100BASE-T1L Block Structure

- ▶ This presentation presents an update to the text for clause 199.3.3.4 Block structure in draft 0.2
 - As we discussed in our presentation at the February Electronic Interim there is ambiguity and missing cases in the current tables and text used in draft 0.2 and this needs be addressed for draft 1.0
 - See [Comments on 802.3dg Draft 0.2](#)
- ▶ This update does NOT include support for sequence ordered sets
 - We believe that writing this clause unambiguously while also supporting sequence ordered sets would require the use of a state diagram and this is significantly more complicated
- ▶ This version does include support for Assert Remote Fault
 - The use of Assert Remote Fault is discussed in [Murray_01_03122025](#)

Proposed Text for Draft 1.0 – Block Structure

Figure 199-5—
PCS Transmit bit ordering

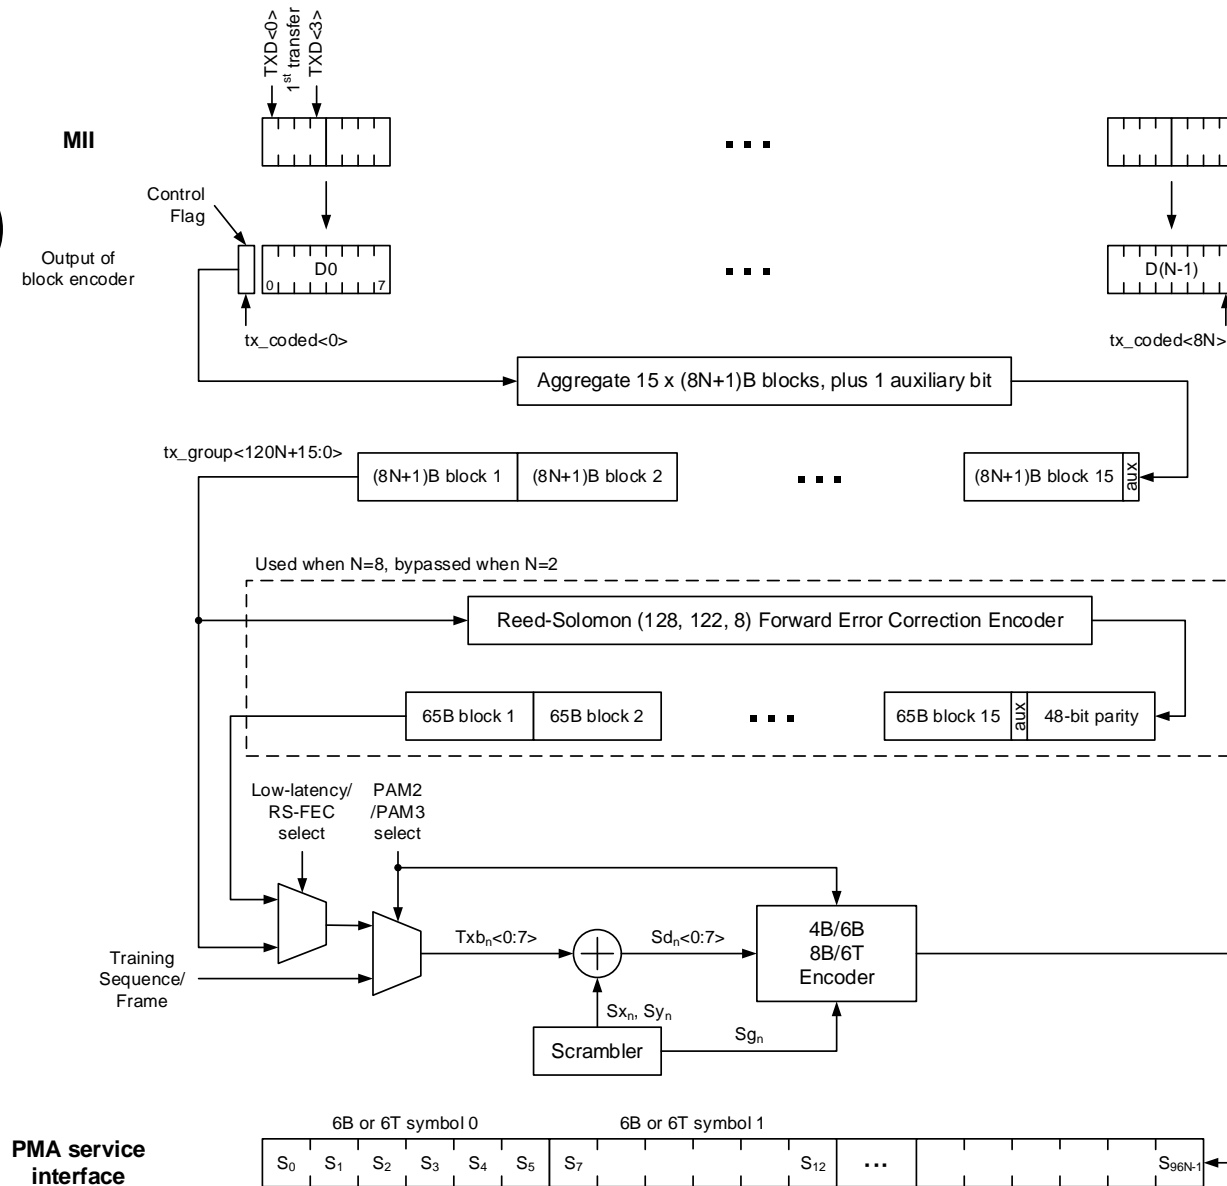
- ▶ Figure 199-5 is a diagram showing the mapping of the MII transfers to the $8N/(8N+1)$ blocks and 6T symbols
